Re: Rapiscan AIT System Radiation Survey Reporting

R-0646-1 Addendum (Documentation Errors)

| Product Name | Secure 1000SP (Single Pose) |
| Serial Number | S51002004 |

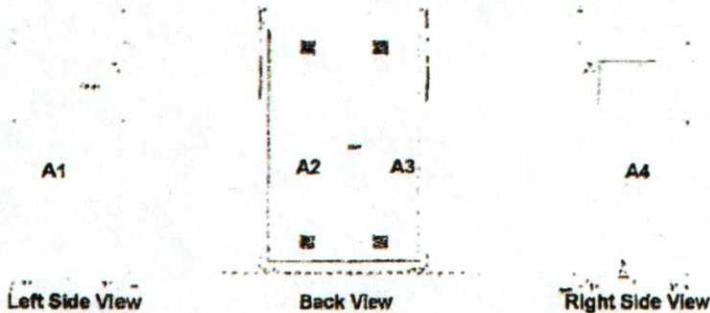
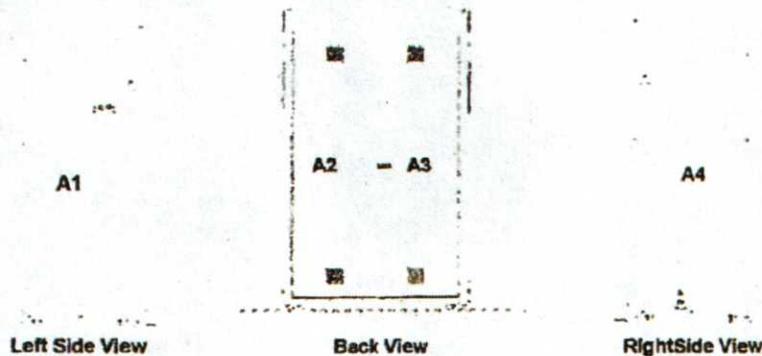
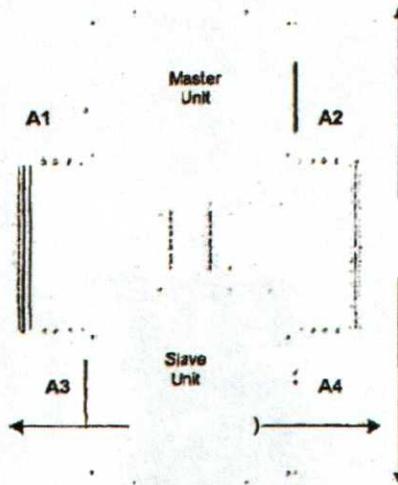
Calculation Error

1. Technician indicated scan time as 7 seconds. Correct scan time is 3 seconds.
2. TABLE 1: Incorrect presentation of data in Column 3 for Measured Exposure. Indicated values are 12 uR and 21 uR. Corrected values are 1.2 uR and 2.1 uR.
3. TABLE 1: Incorrect presentation of data in Column 6 for Effective Dose. Indicated values are 21.6 uRem and 37.8 uRem. These figures were stated based on incorrect math calculations. Corrected values, as calculated by RSO, are .69 uRem and 1.21 uRem. RSO corrected effective dose based on Measured Exposure as captured during the field survey.

CORRECTIVE ACTION

The service technician should attend refresher training as soon as possible with an emphasis on measurement methodology.

The corrected data indicates this system was operating within expected parameters. No re-survey is required for this system.
